**JONATHAN GLASSBERG**

**44 FROGNAL LANE LONDON NW3 6PP**

**DESIGN AND ACCESS AND HERITAGE STATEMENT**

**March 2015**

**Proposed AHU**

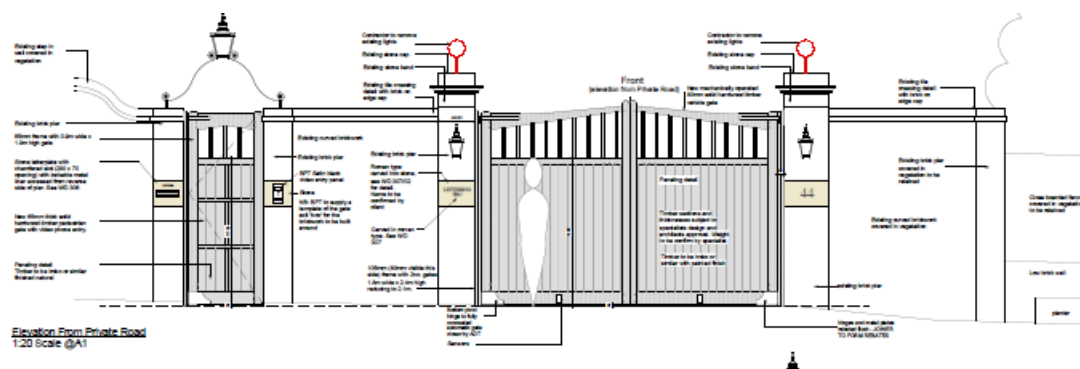
6. **1230/AP 01E:** The proposed site plan has been amended to include new mechanical services equipment consisting of:
- an air conditioning unit (Daikin VRV Heat Pump model RYYQ10T) installed externally within the garden in a plant enclosure and
  - a fresh air / exhaust Air Handling Unit (AHU) (Recotherm model VFEC100) serving the swimming pool, installed internally within the basement plant room with external intake and discharge apertures within the garden.

7. The external condenser includes acoustic panelling of a steel frame spanning between mini screw piles with a bottom plate. A cardboard layer is placed on the ground to create a void and the frame is then infilled with concrete to ensure the condenser sits on the surface ground protecting any existing tree roots.

#### Replacement Gates from Froggal Lane (North)

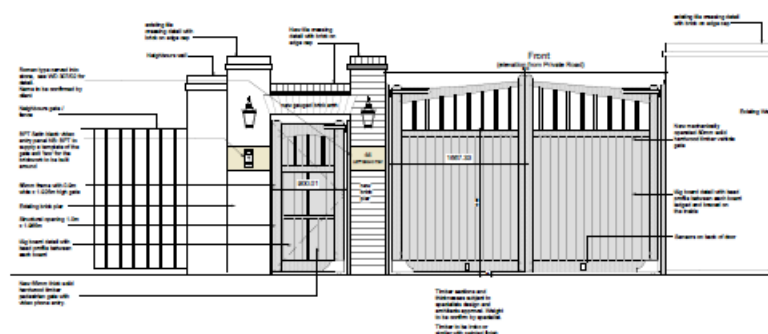
10. **1230 WD 302A:** The replacement vehicle gate is mechanically operated 80mm solid timber to be Iroko or similar with painted finish. The pedestrian gate is 65mm thick solid hardwood timber.
